ADDENDUM NO. 3

Project: City of Whitefish Wastewater Treatment Plant Improvements Project - 2019

Date of Addendum: October 23, 2019

SKS
SKS-1

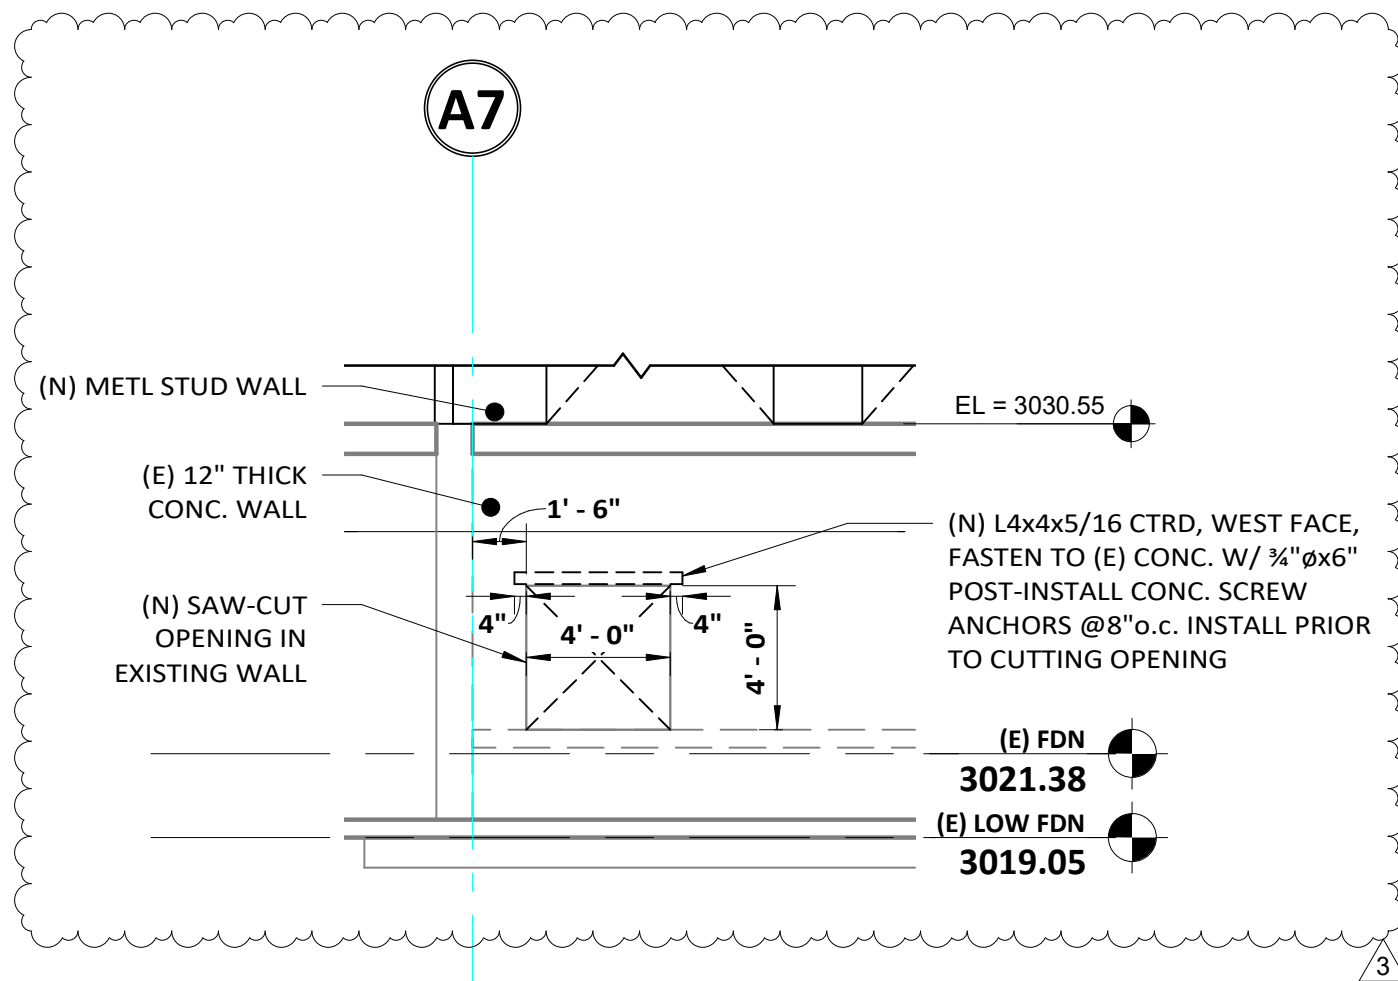
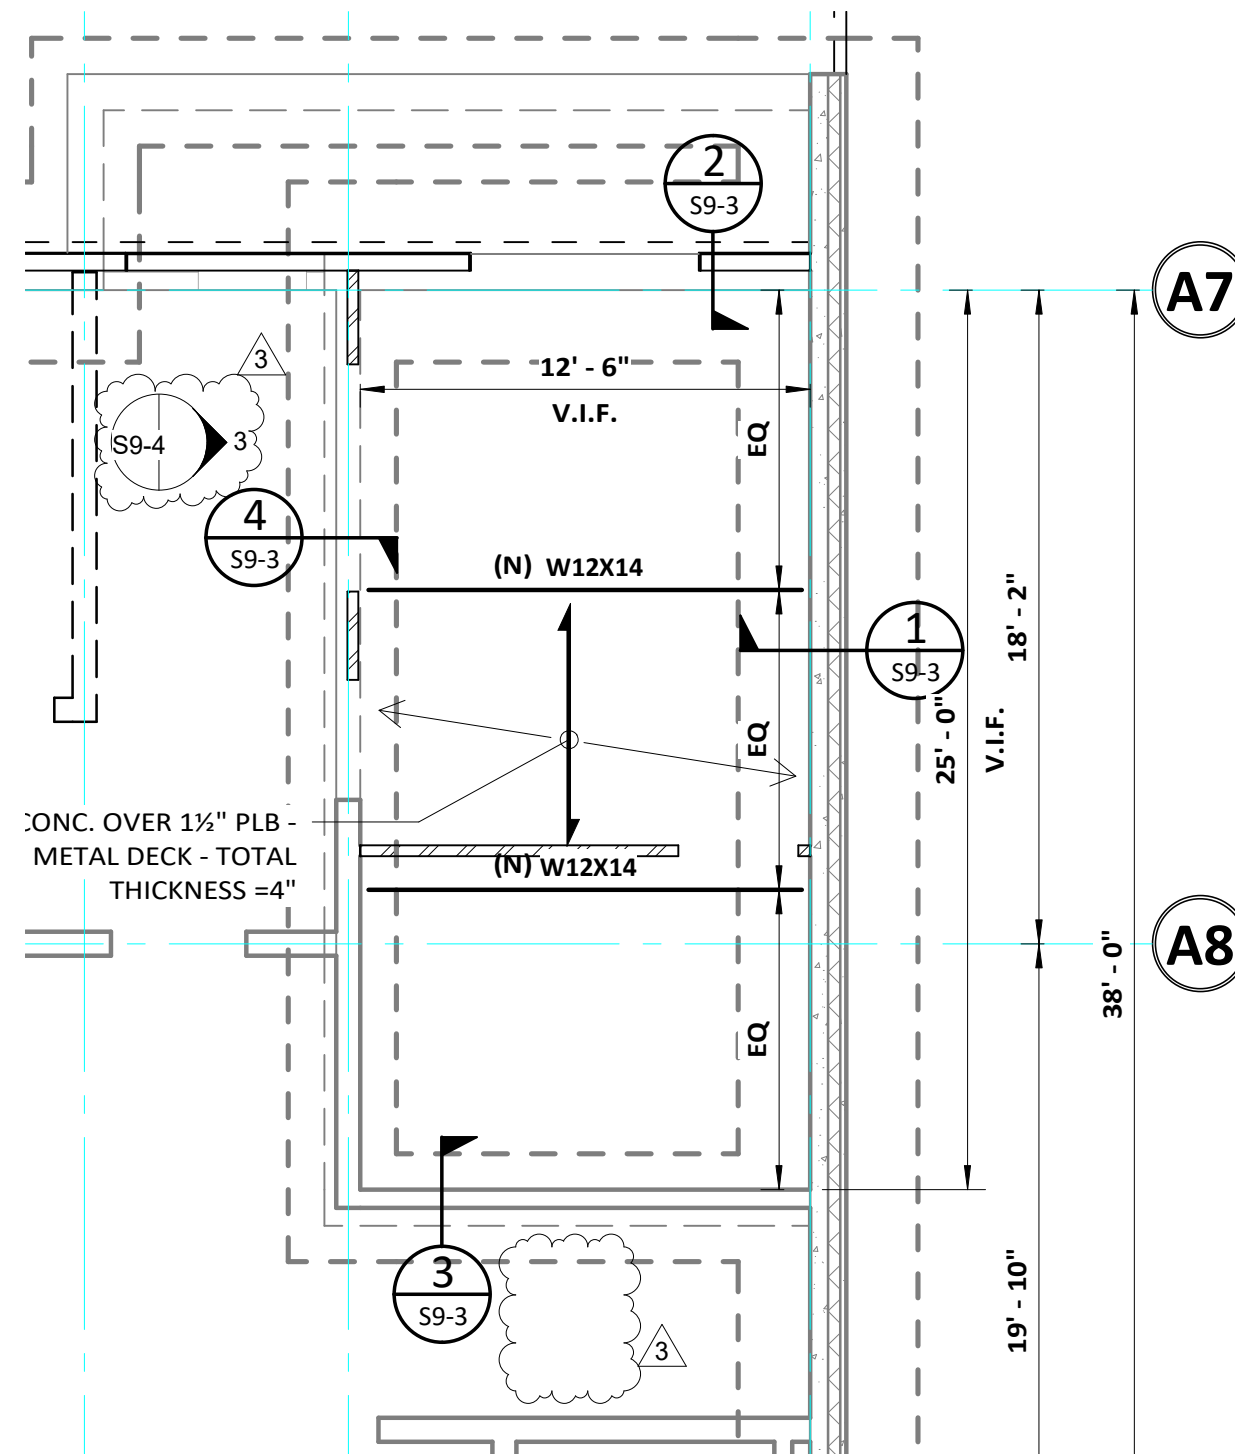
14. Sheet S9-4 – Detail 3: New Opening in Basement Wall of Adm. Bldg.

The new opening into the crawlspace under the new conference room (currently occupied by the two alum tanks) will be relocated from the south wall to the north end of the west wall. Attached Sheet SKS-1 defines the new location for the crawl space access.

SKS-2

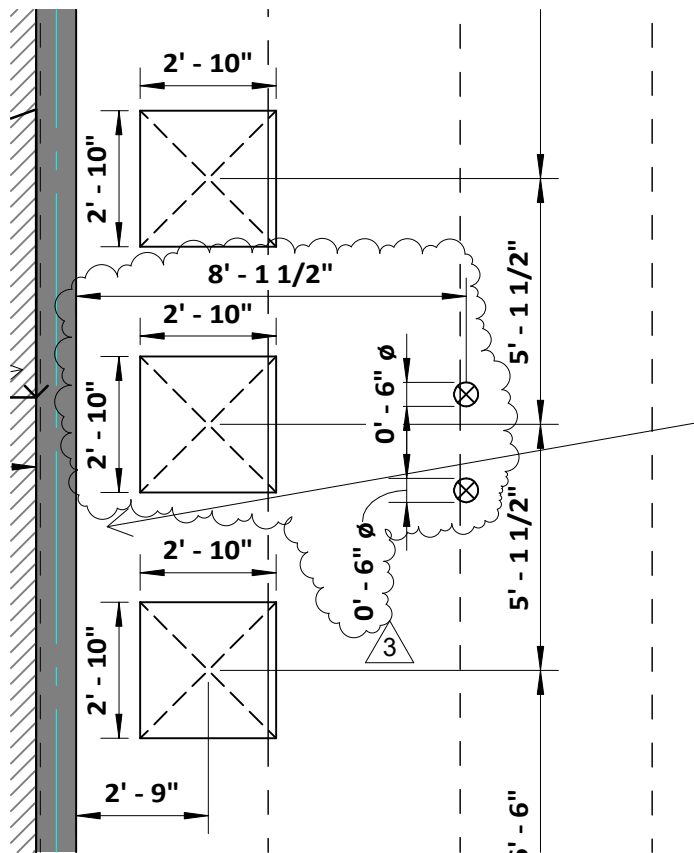
10. Sheet S4-6 – Roof Drains and HVAC Openings in MPB Roof Framing Plan:

The roof drain penetrations and HVAC openings immediately east of Section “D” are modified according to attached Sheet SKS-2 – Revisions to Main Process Building Roof Framing Plan

SKS-3

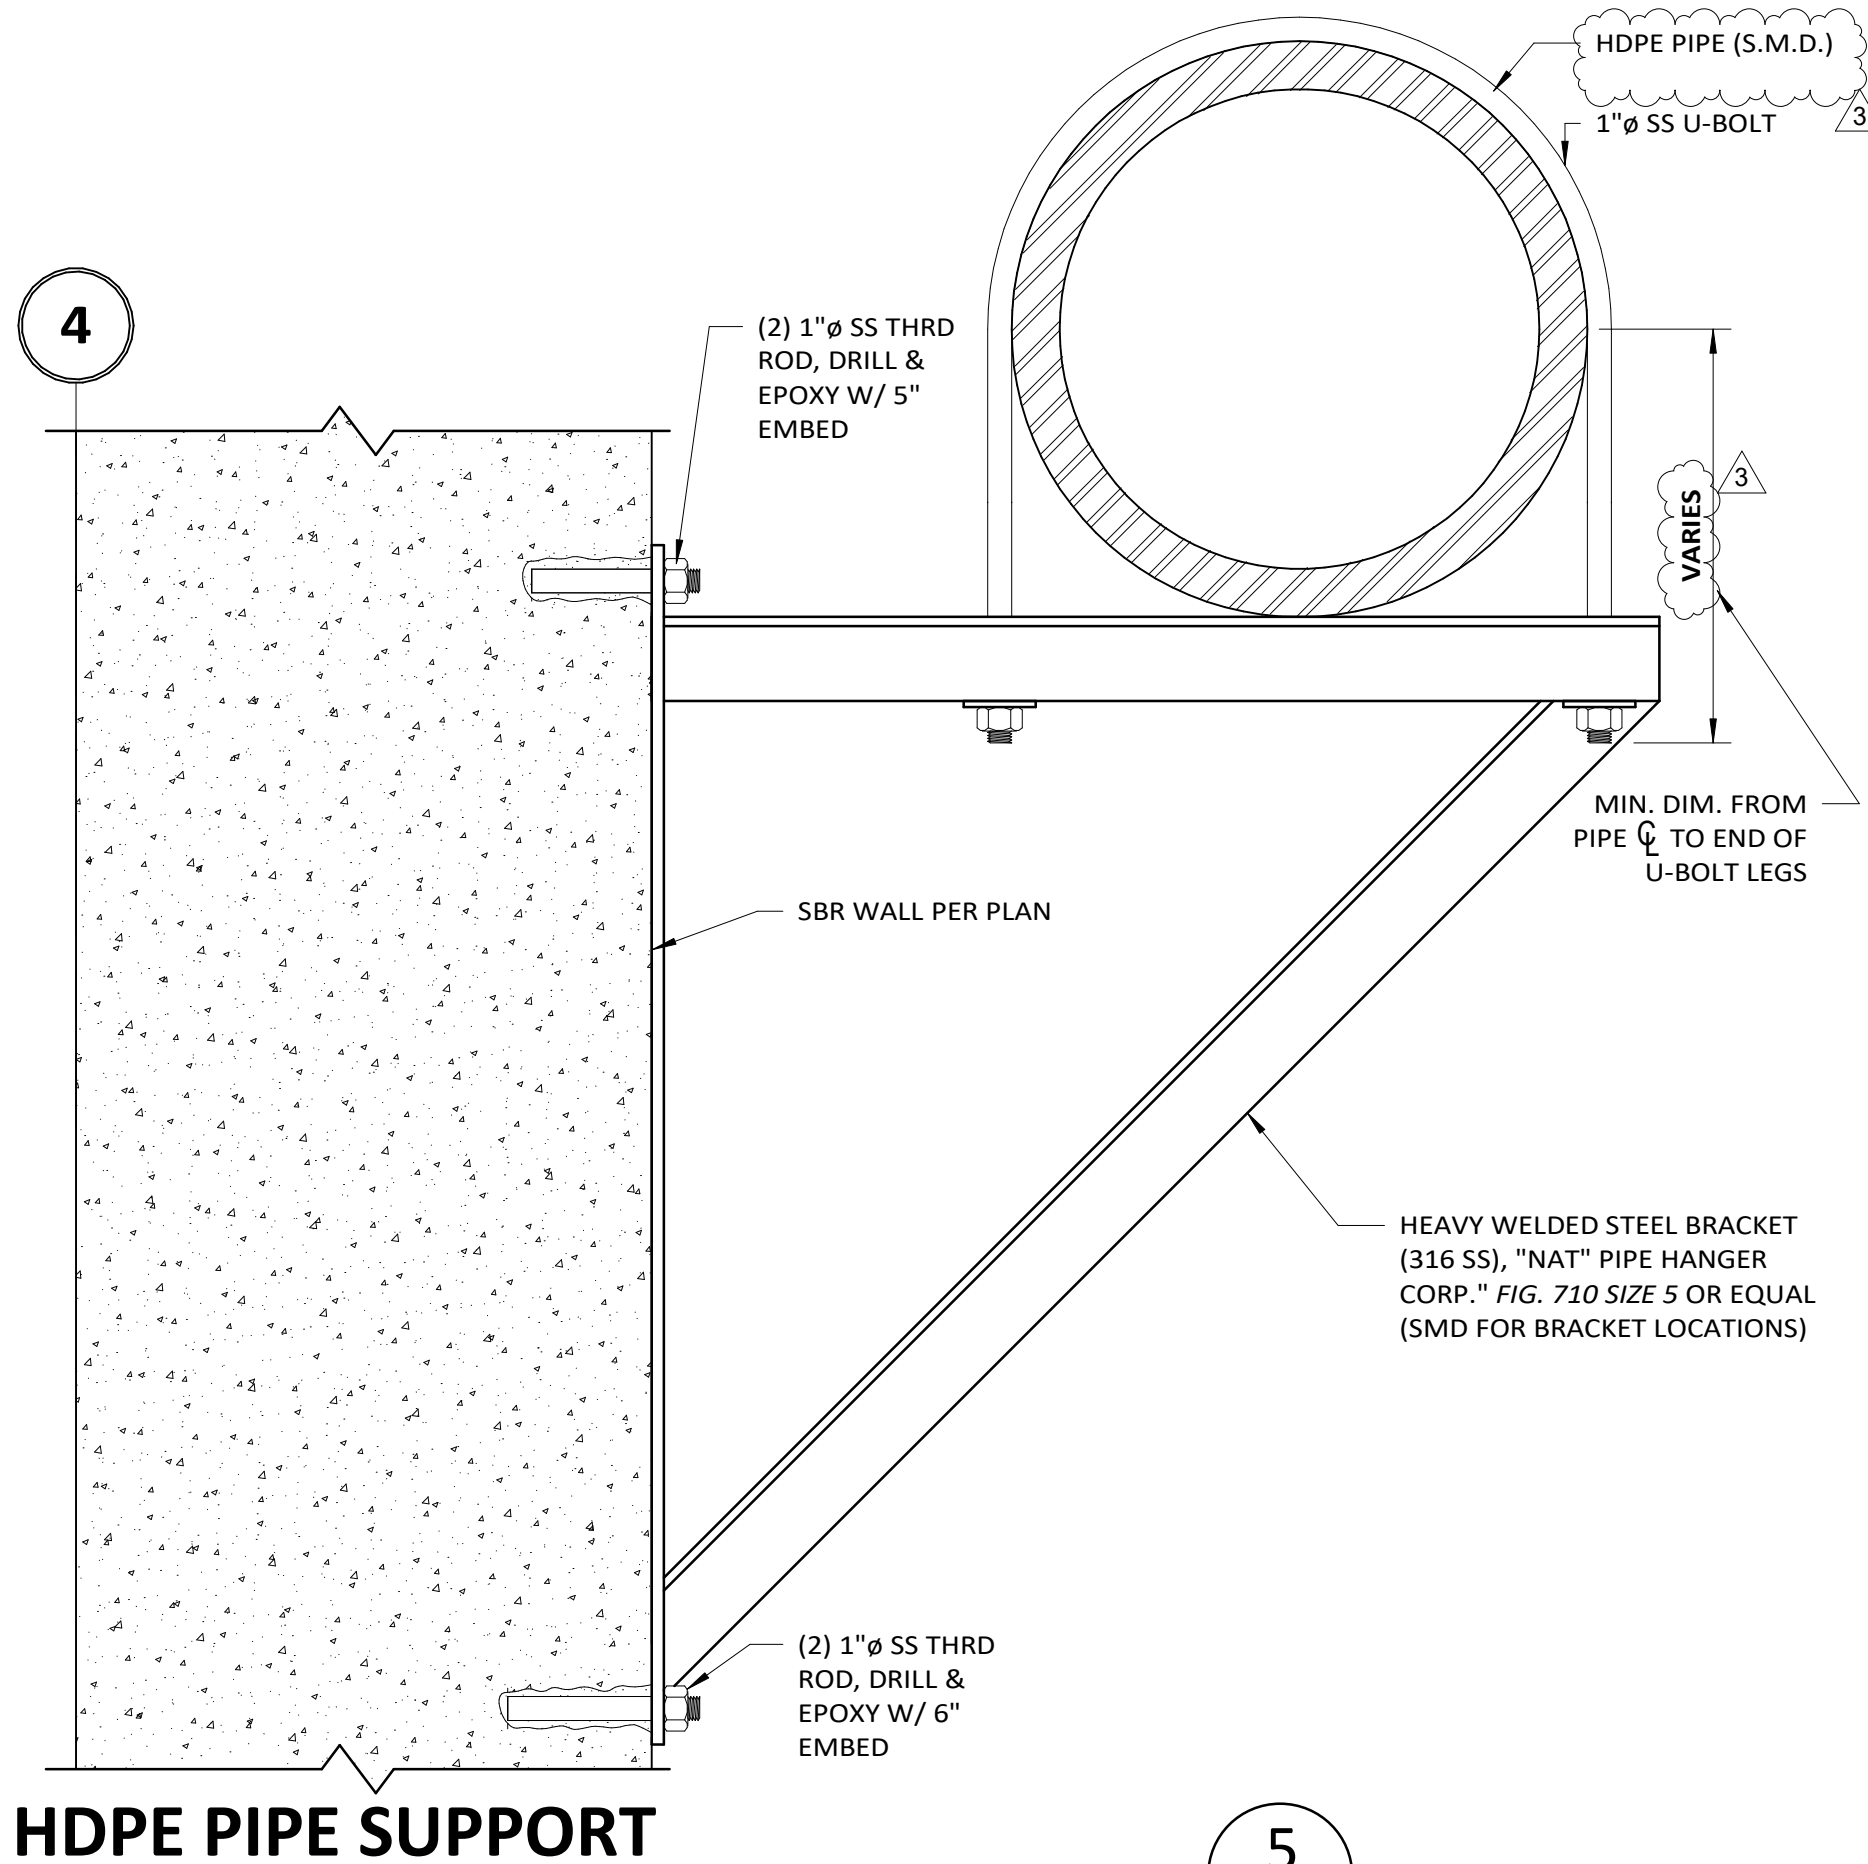
8. Sheet S3-15 – Detail 5: 20" HDPE Pipe Support:

This detail is replaced by that shown on attached Sheet SKS-3 – Pipe Support

SKS
SKS-4

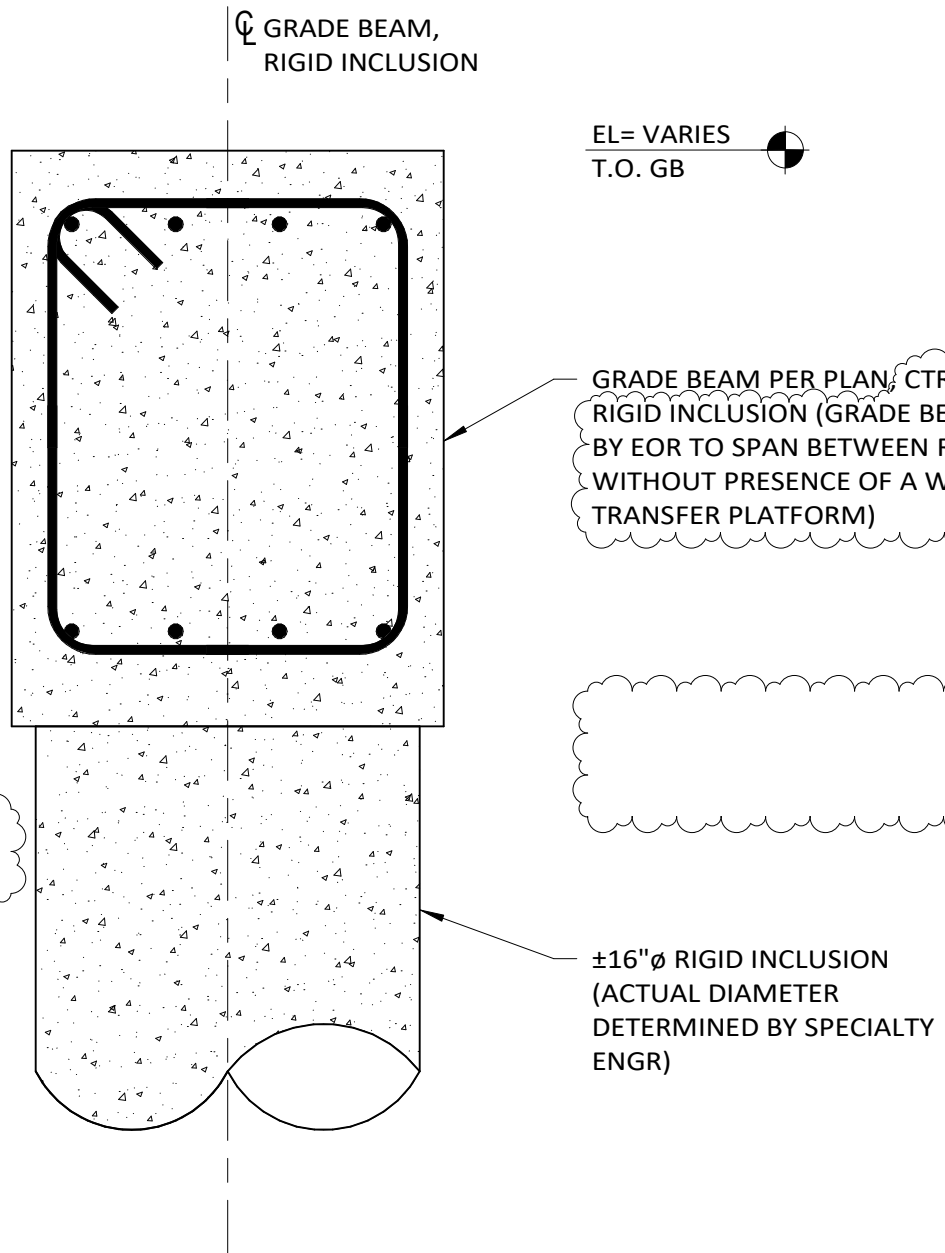
11. Sheet S4-12 – Detail 2:

This detail is replace by that shown on attached Sheet SKS4 – Typical Grade Beam to Rigid Inclusion Connection

Top of RI elevations are per RI specialty engineer. Grade beams are conservatively designed to clear span between individual RI's at assumed spacing shown on sheet S4-3 and S4-4. If working/load transfer platform is capable of transmitting specified reactions from bottom of grade beams to top of RI's, as determined by the specialty engineer, the RI's are not required to be in direct contact with the grade beams. Detail 2/S4-12 has been revised to remove the reinforcing extending from top of RI into bottom of grade beam.

SKS-7

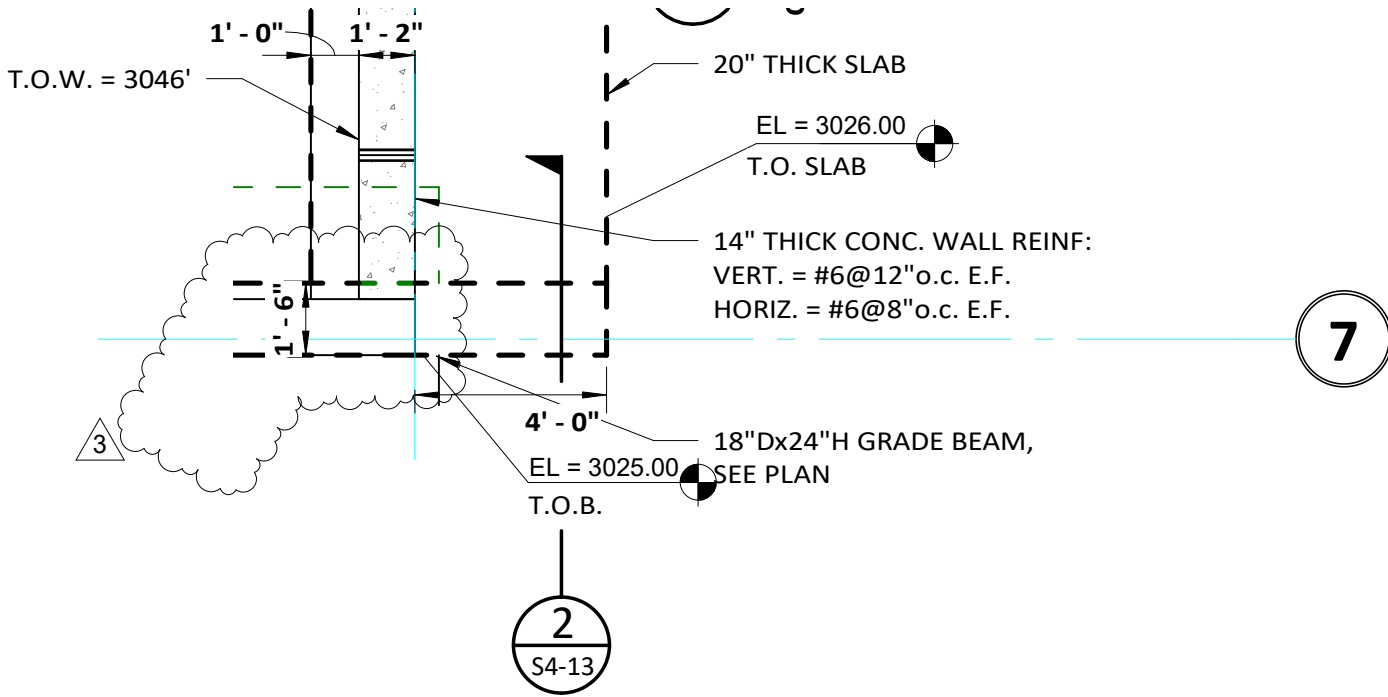
12. Sheet S5-2 – Detail 1

Detail 1 on Sheet S5-2 is revised as per SKS-7 attached.
